3B Containment Hydrodynamic Loads

The information in this appendix of the reference ABWR DCD, including all subsections, tables, and figures, is incorporated by reference with the following departures.

STD DEP 3B-2 (Table 3B-1, Figures 3B-12 and 3B-13)

Figure 3B-12 Time History of Air Bubble Pressure

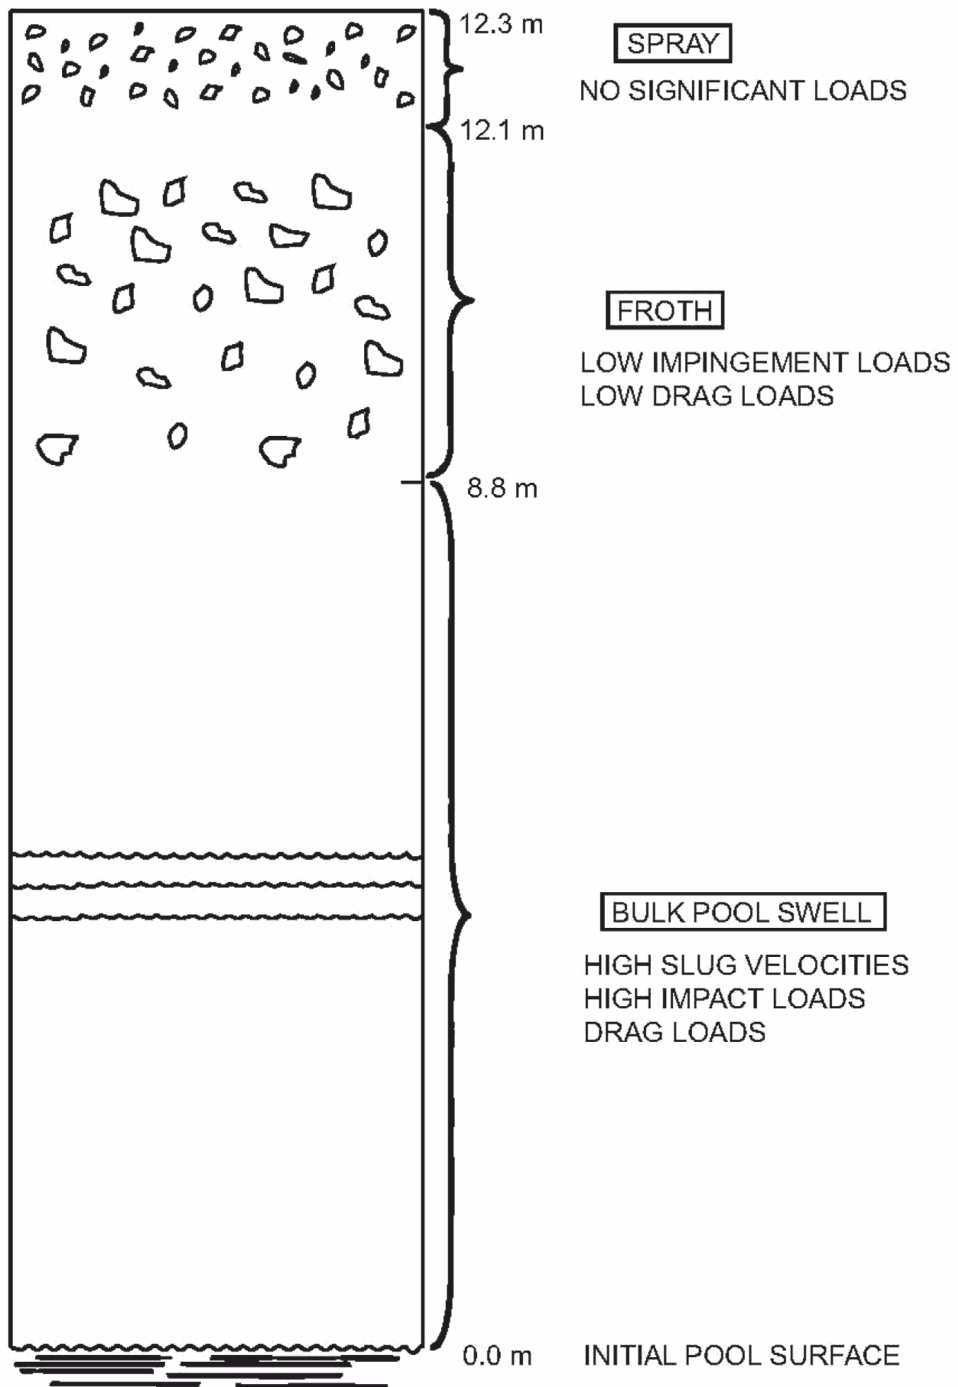
Description	Value
1. Air bubble pressure (maximum)	133.37 kPaG 195 kPaG
2. Pool swell velocity (maximum)	10.9 m/s
3. Wetwell airspace pressur (maximum)	107.87 kPaG 146 kPaG
4. Pool swell height (maximum)	7m 8.8m

Figure 3B-13 Schematic of the Pool Swell Phenomenon

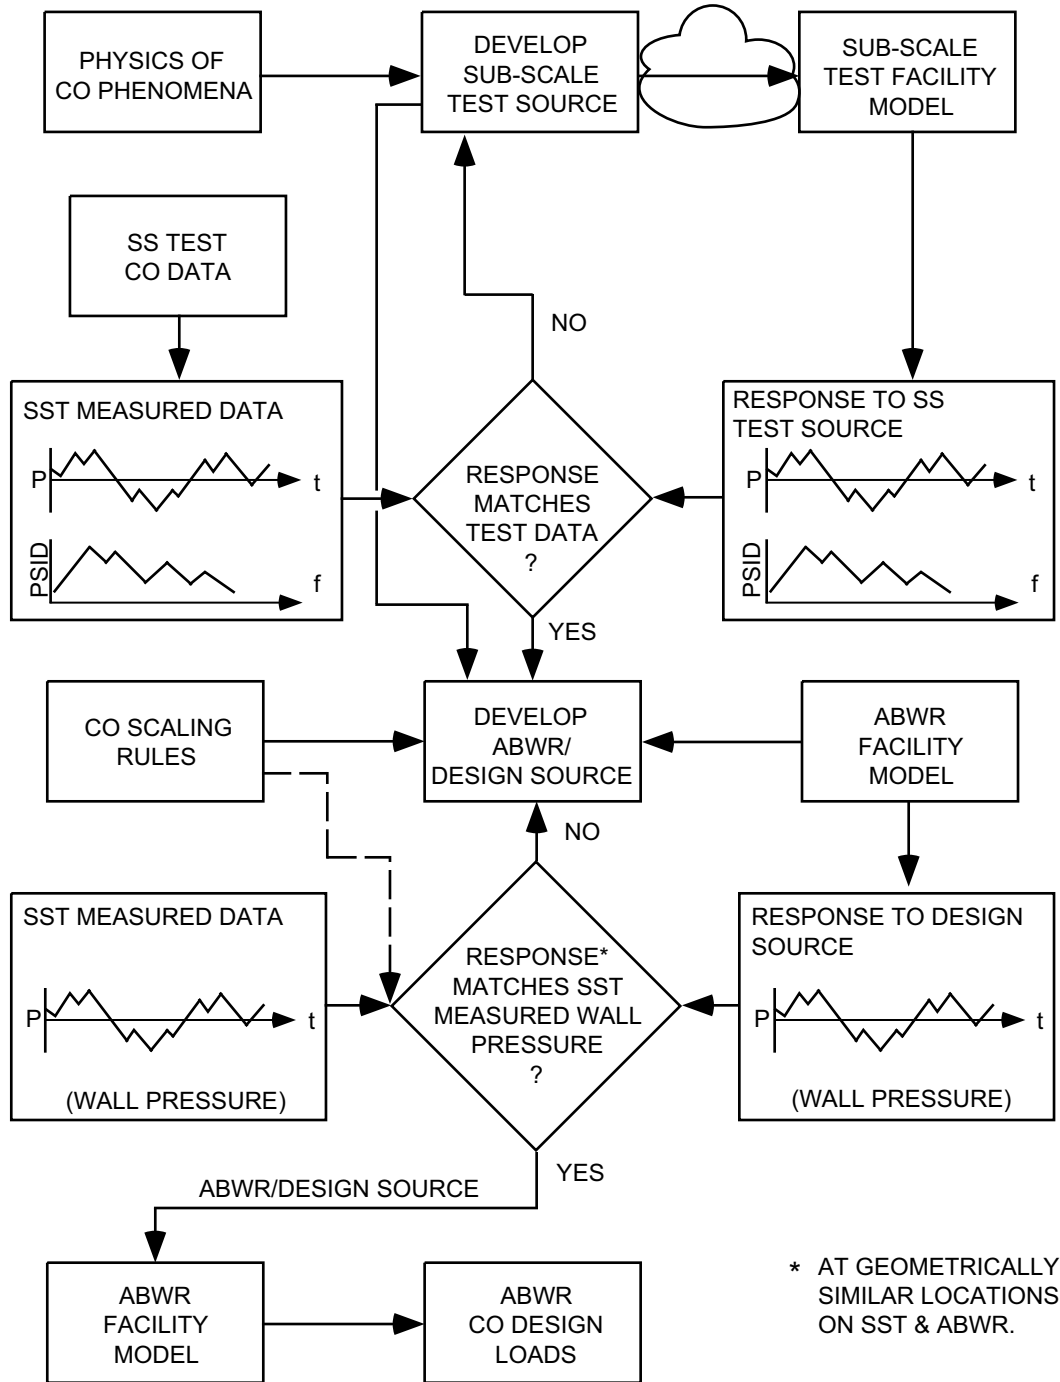
Structures located between 0 and ~~7m~~8.8m above the initial surface will be subjected to impact load by an intact water ligament, where the ~~7m~~8.8m value corresponds to the calculated maximum pool swell height. The load calculation methodology will be based on that approved for Mark II and Mark III containments (NUREG-0487 and NUREG-0978).

Structures located at elevations between the ~~7m~~8.8m and ~~40.3m~~12.1m will be subjected to froth impact loading. This is based on the assumption that bubble breakthrough (i.e., where the air bubbles penetrate the rising pool surface) occurs at ~~7m~~8.8m height, and the resulting froth swells to a height of 3.3m. ~~This froth swell height is the same as that defined for Mark III containment design and this.~~ This is considered to be conservative for the ABWR design. Because of substantially smaller wetwell gas space volume (about 1/5th of the Mark III design), the ABWR containment is expected to experience a froth swell height substantially lower than the Mark III design. The wetwell gas space is compressed by the rising liquid slug during pool swell, and the resulting increase in the wetwell gas space pressure will decelerate the liquid slug before the bubble break-through process begins. The load calculation methodology will be based on that approved for the Mark III containment (NUREG-0978).

As shown in Figure 3B-13 the gas space above the ~~40.3 m~~12.1m elevation will be exposed to spray condition ~~including~~ which is expected to induce no significant loads on structures in that region.

Figure 3B-21 ABWR CO Source Load Methodology

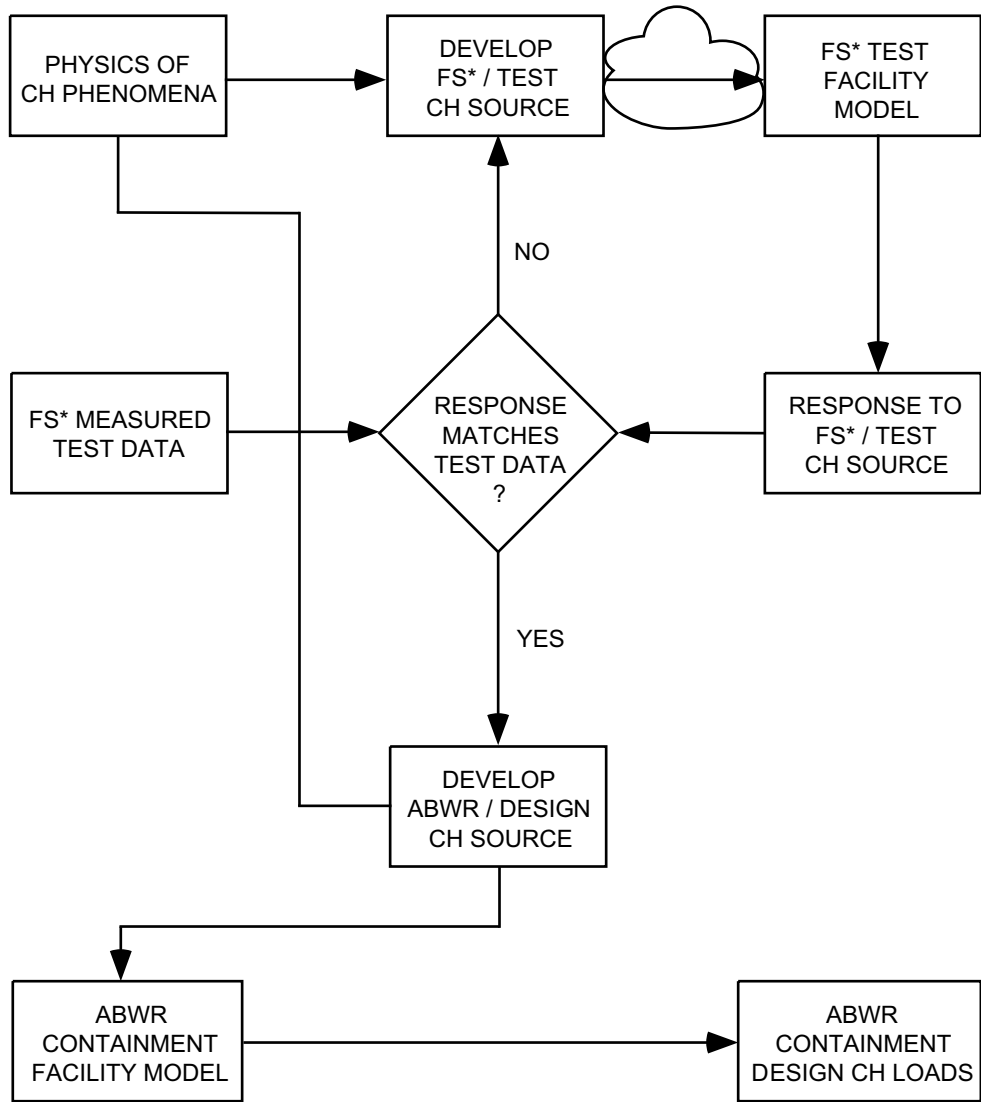
STD DEP Admin (Figures , 3B-21, 3B-24, 3B-26)
